Town of Hilton Head Island  
**Design Review Board Meeting**  
**Tuesday, June 22, 2021 – 1:15 p.m.**  
**AGENDA**

i. The Charles, DRB-001440-2021

i. Pope Ave Starbucks, DRB-001318-2021

## DESIGN TEAM/DRB COMMENT SHEET

1 FRONT ELEVATION  
A2.1

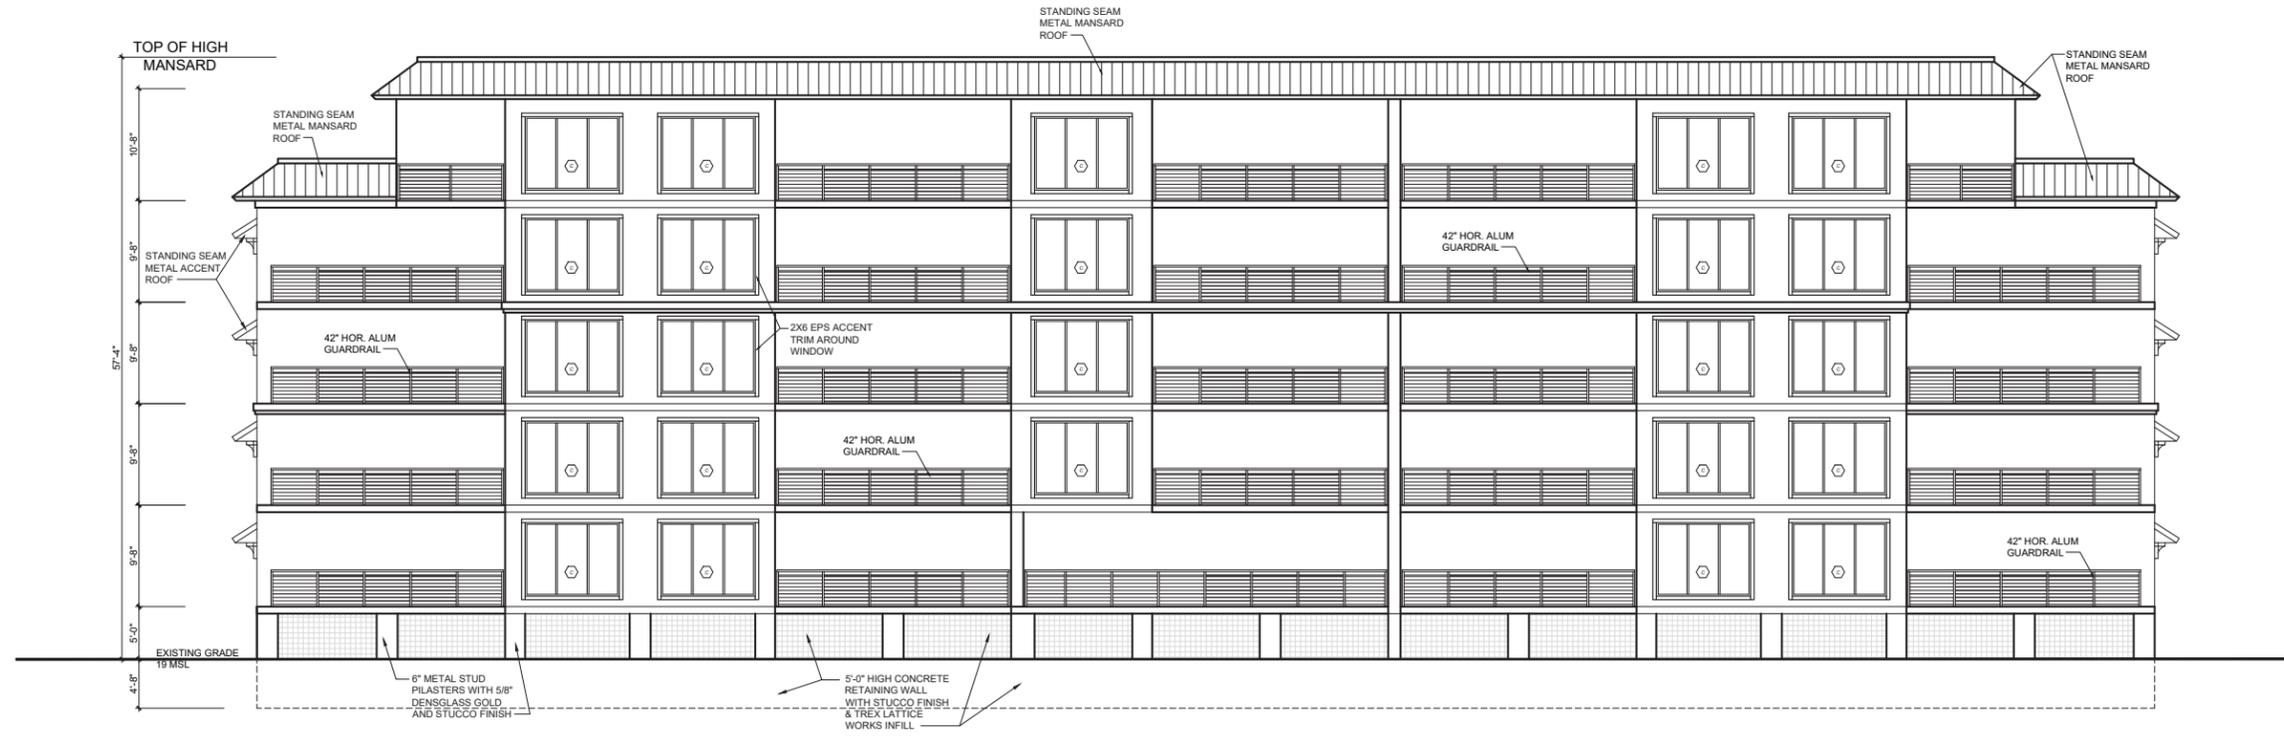
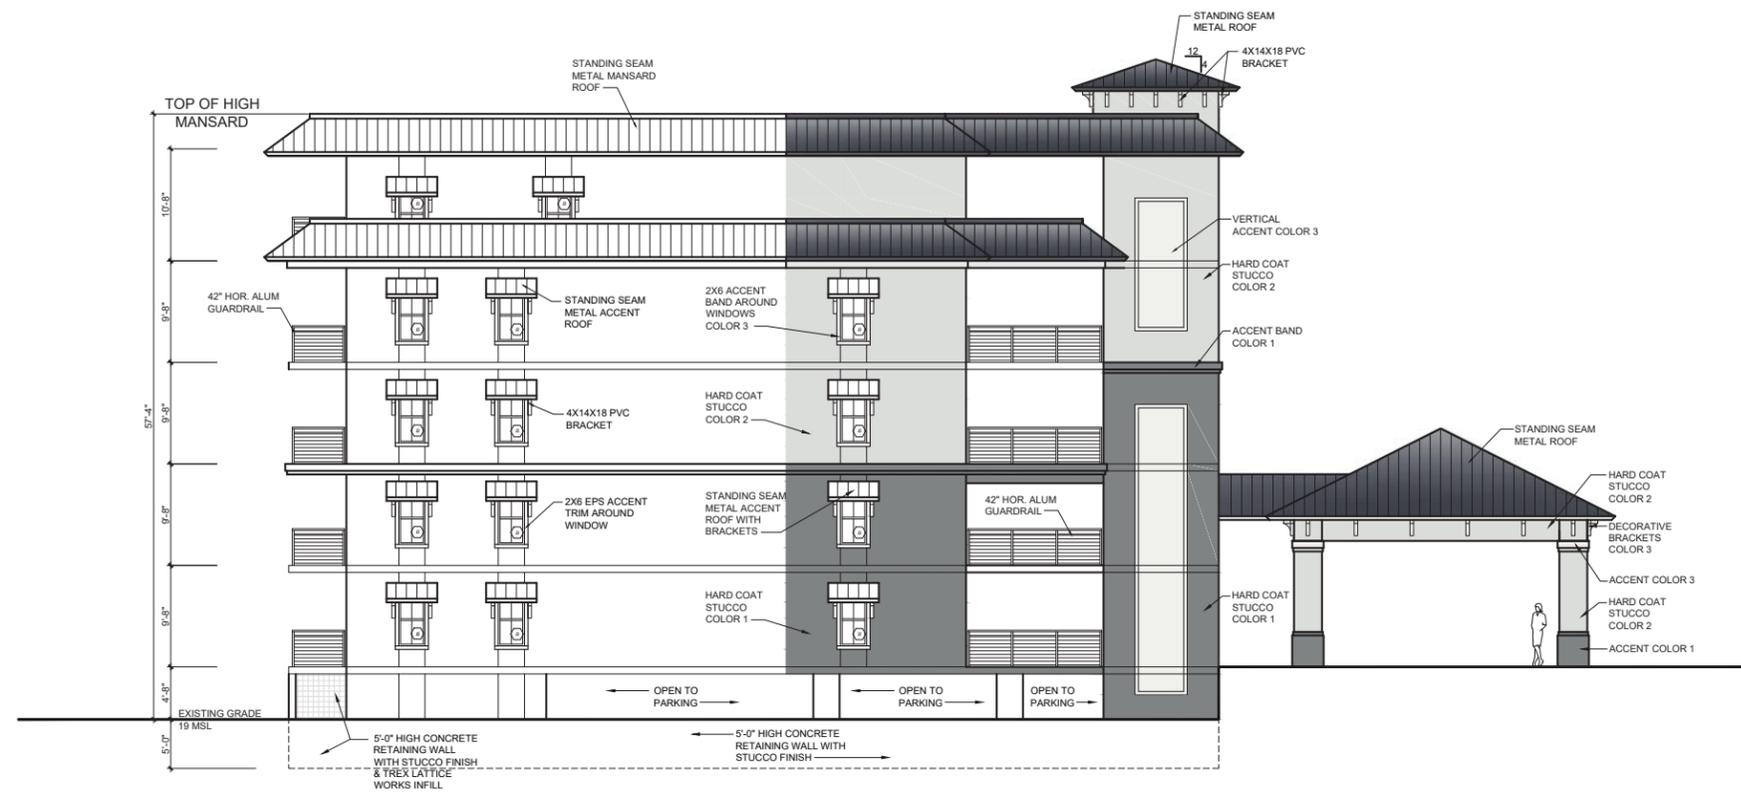
All facades are have equal design characteristics	<input type="checkbox"/>	<input checked="" type="checkbox"/>	<input type="checkbox"/>	The “Back Elevation” sheet A2.1 lacks the architectural interest of the “Front Elevation”.
Avoids monotonous planes or unrelieved repetition	<input type="checkbox"/>	<input type="checkbox"/>	<input type="checkbox"/>	
Has a strong roof form with enough variety to provide visual interest	<input type="checkbox"/>	<input checked="" type="checkbox"/>	<input type="checkbox"/>	The tower elements to the left and right of the porte-cochere seem unfinished without a roof.
Human scale is achieved by the use of proper proportions and architectural elements	<input type="checkbox"/>	<input checked="" type="checkbox"/>	<input type="checkbox"/>	Revise the “vertical accents” on the elevator towers to be more in scale with the size of windows.
Utilizes a variety of materials, textures and colors	<input type="checkbox"/>	<input checked="" type="checkbox"/>	<input type="checkbox"/>	Consider use of another material on the exterior of the building.

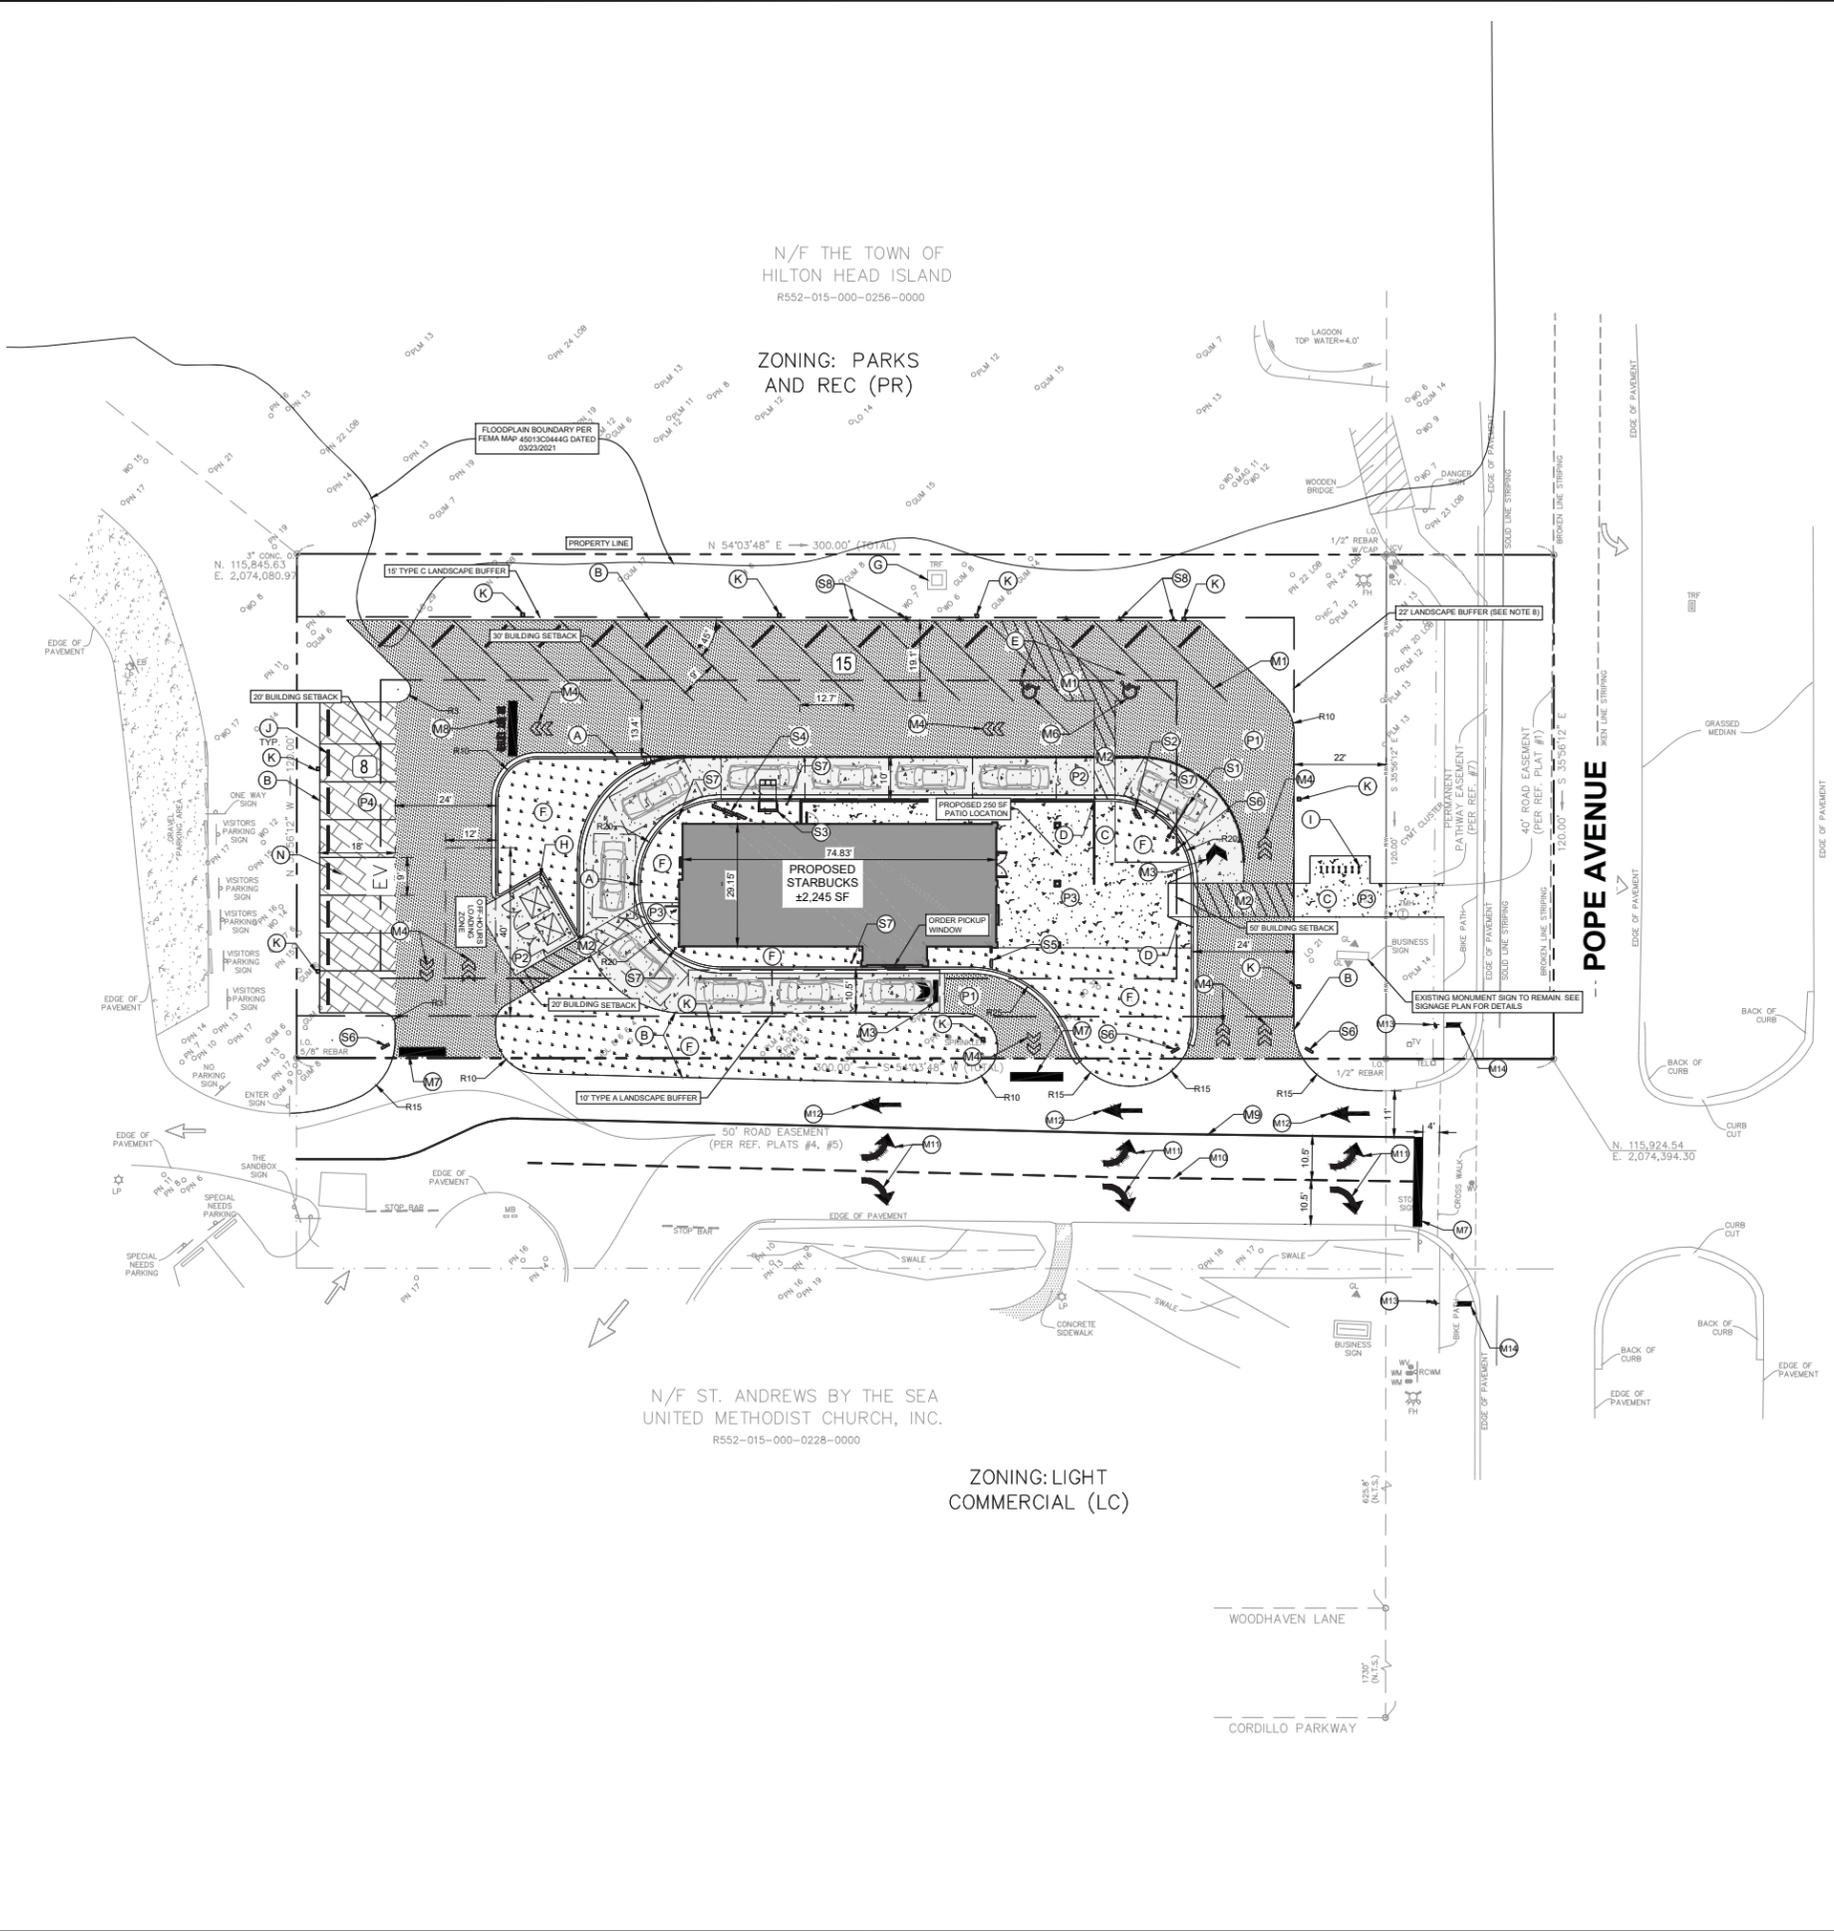
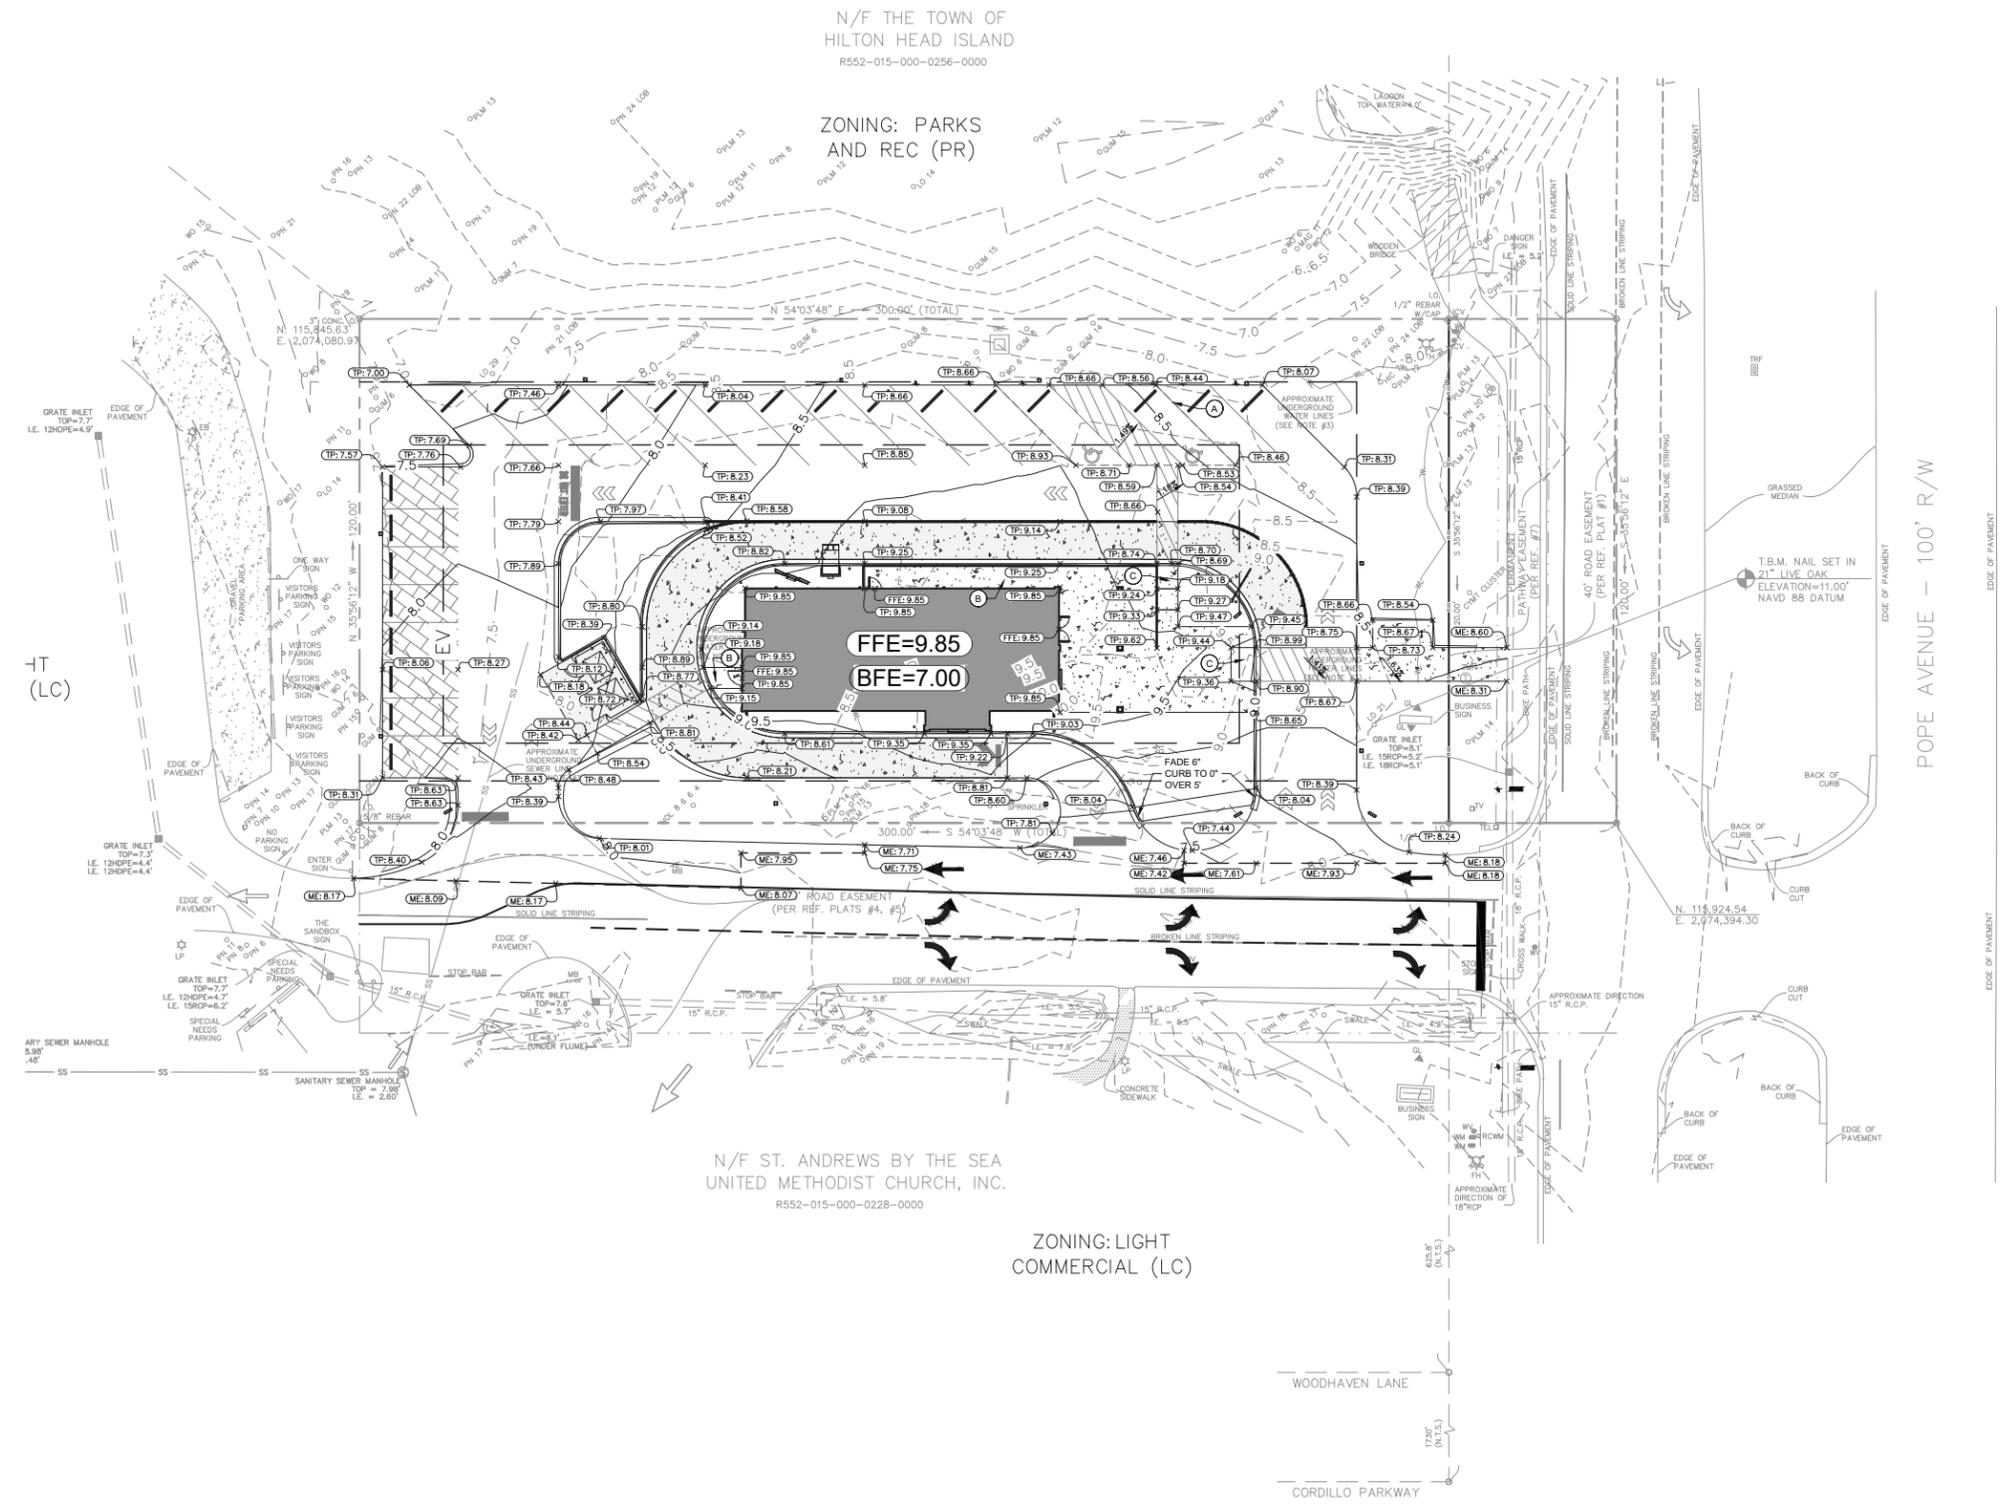
- 14) Vehicular circulation on the site is congested and not clear. This includes the parallel parking. Staff has generated attached site plan that improves circulation and eliminates the parallel parking. – The provided site plan sketch was extremely helpful and provided the basis for the newly submitted site plan submitted. In collaboration with staff, we feel the revised site design meets the goals of the staff, our client and the overall design goals of Hilton Head Island.
